Quartz Valley Indian Reservation  
13601 Quartz Valley Road Fort Jones, CA 96032  
ph: 530-468-5907 fax: 530-468-5908

November 2, 2005

The Quartz Valley Indian Community of Quartz Valley Indian Reservation (QVIR), with the assistance of our consultants Kier Associates, have reviewed the public draft version of the North Coast Regional Water Quality Control Board's (RWB) Staff Report for the *Action Plan for the Scott River Watershed Sediment and Temperature Total Maximum Daily Loads* (Scott TMDL). As stated in previous comments, the Tribe hopes that the Scott TMDL will result in measurable and timely improvements in the water quality of the Scott River watershed. Please realize that QVIR is the only federally recognized, sovereign tribal government in the Scott Valley. The consideration that the Board gives to our comments should be representative of this fact.

## Summary of Comments

Figure 17. This map shows timber harvests on private land between 1991 and 2001, according to CDF, for the Mill Creek Calwater (upper Etna Creek). Timber harvest in recent years seems concentrated in near stream areas and other larger harvests overlap riparian zones.

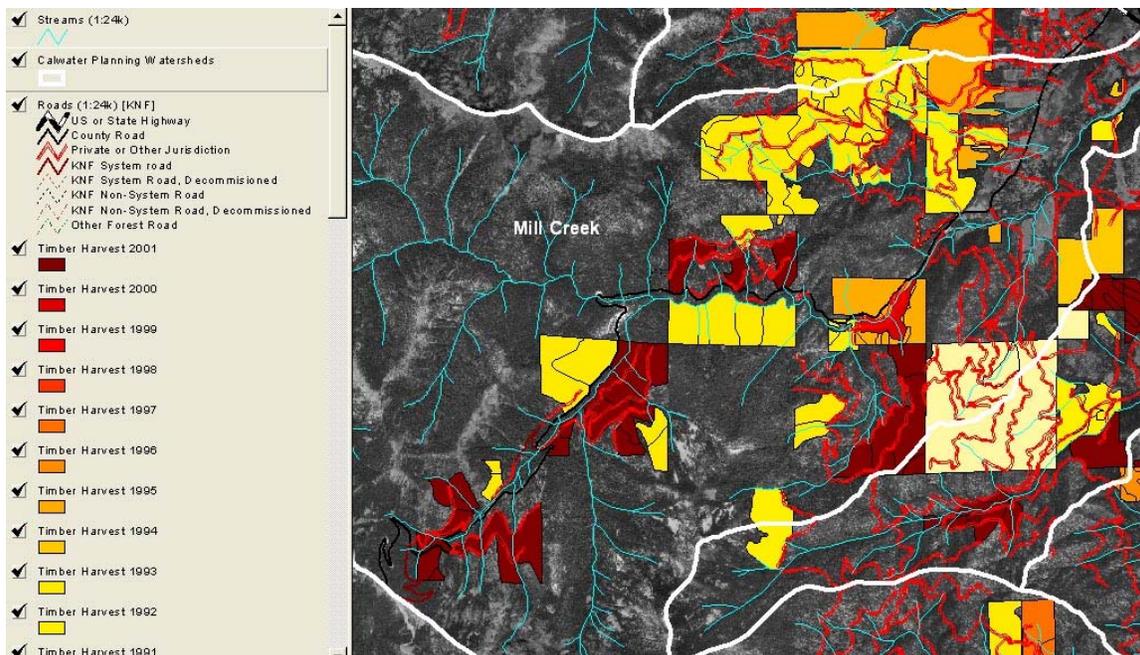
2.5.2 Temperature-Related Desired Conditions: Coho salmon represent the most sensitive beneficial use in the Scott River basin and the final Scott TMDL must recognize the findings of Welsh et al. (2001) and the recommendations of the U.S. EPA (2003) in establishing a floating weekly average temperature of 16.8 C or less in any habitat inhabited by coho juveniles. In order to attain these conditions, impacts from riparian zone timber harvest must be limited and the interval of damaging flood flows must be decreased. In fact, logging in the riparian zone of Scott River tributaries has been active (Figure 17).

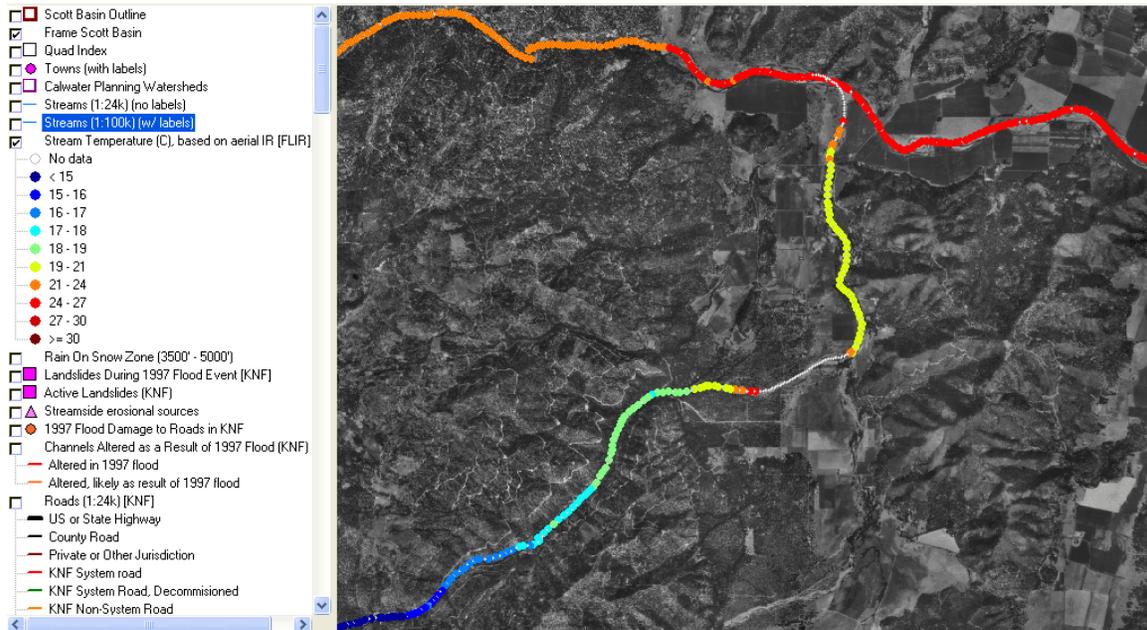
The final Scott TMDL needs to call for the RWB to exert authority in cases such as Shackleford Creek (Figure 19) where the depletion of flows makes achievement of water quality objectives impossible. The State Water Resources Control Board has the authority to require increased bypass flows to meet water quality standards as established in Supreme

Figure 19. This chart from Bartholow (1989) shows that air temperature and relative humidity have a greater effect on mean daily water temperature than shade.

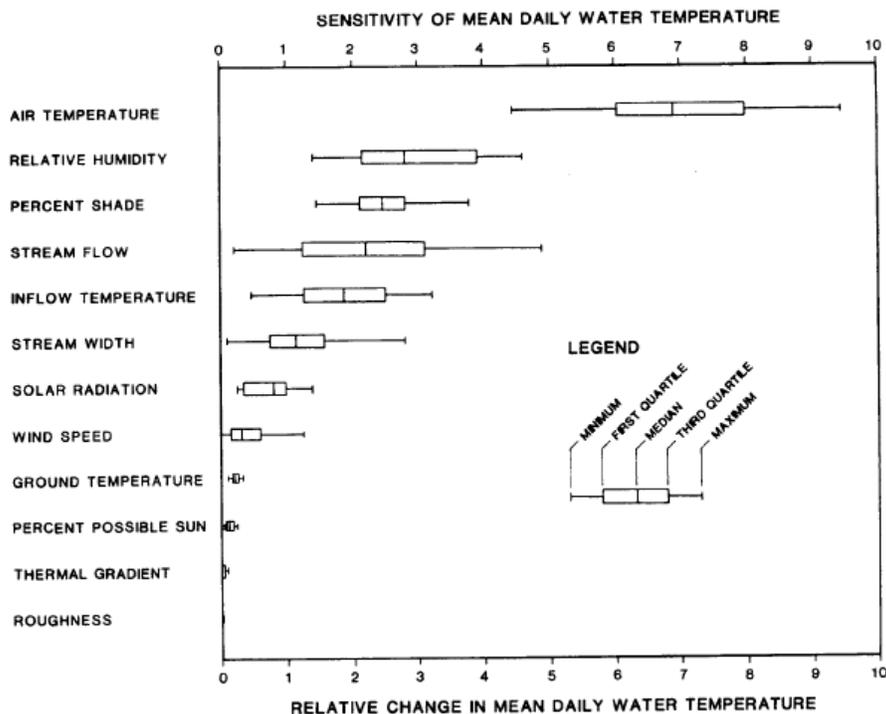
4.1.1 Temperature Sources: Stream Heating Processes: Scott TMDL discussions of temperature pollution do not reflect a current “best science” understanding of riparian conditions, air flow over the stream and their relationship to water temperature. The final document needs to reference Bartholow (1989), Essig (1998) and Poole and Berman (2001). Bartholow (1989) demonstrated that air temperature over the stream is by far the most significant driver of maximum water temperature (Figure 19).

Figure 20. This figure taken from Chen (1991) shows how various riparian functions important to streams deteriorate as disturbance encroaches into stream side areas. One site potential tree height is likely 150-180 feet in Scott River basin forested areas.

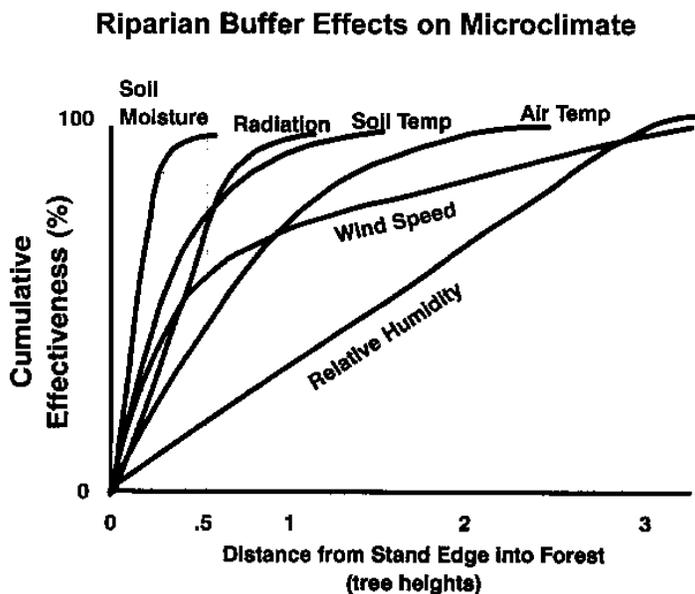
Science associated with the Northwest Forest Plan (FEMAT, 1993) indicates that the zone of riparian influence is two site potential tree heights or more (Figure 20). Water temperature

Figure 23. USGS flow data for the Scott River were used to create the above chart showing an increase in the days with less than 40 cubic feet per second at Fort Jones with a major increase over the period of record.

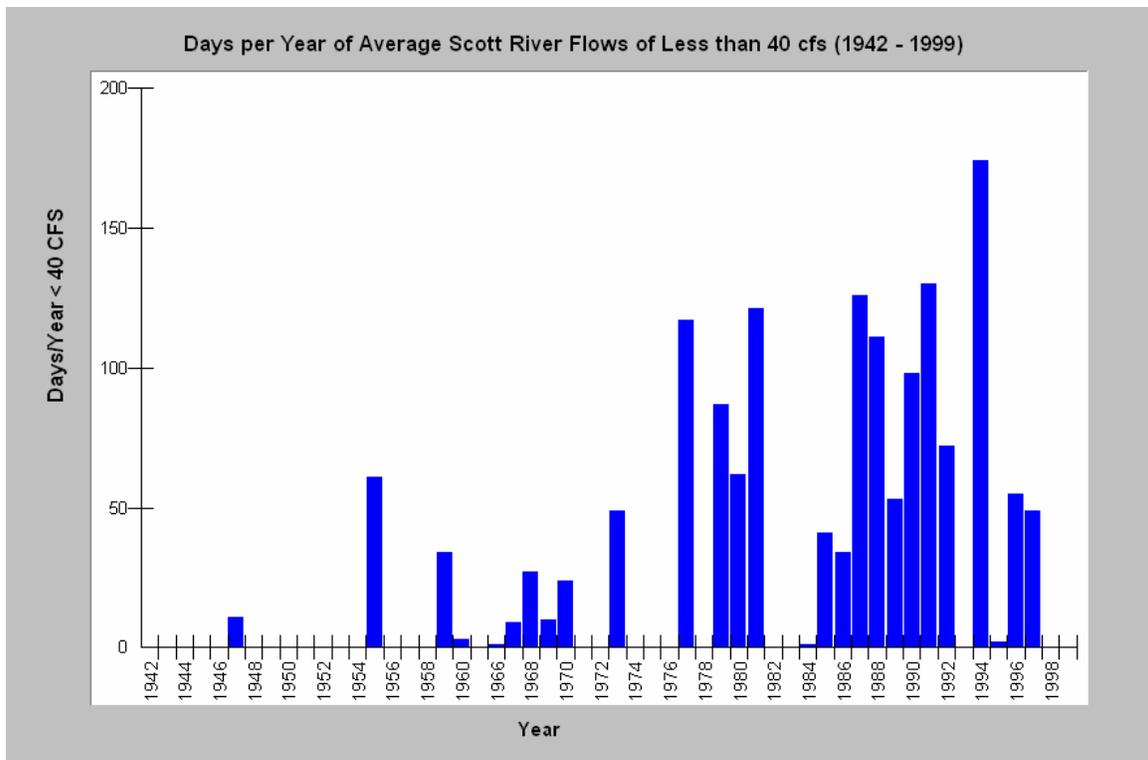
Long-term USGS flow records show clearly that base flows in the Scott River have diminished (Figure 23). Reduced flows result from increased surface diversions, changes in cropping patterns, decreased base flows due to changes in upland conditions, decreased available surface water due to aggradation, and increased groundwater pumping.

The final TMDL should explicitly recognize that the flow trends of recent years are precisely the opposite of those necessary for the recovery of water quality and fish resources. Remedies for flow changes related to watershed conditions and aggradation have been described in previous sections. The final TMDL needs to also recommend that changes in crops from water-hungry alfalfa to high-value dry-farmed species be considered and that implementation of available water conservation measures be instituted by a date certain.
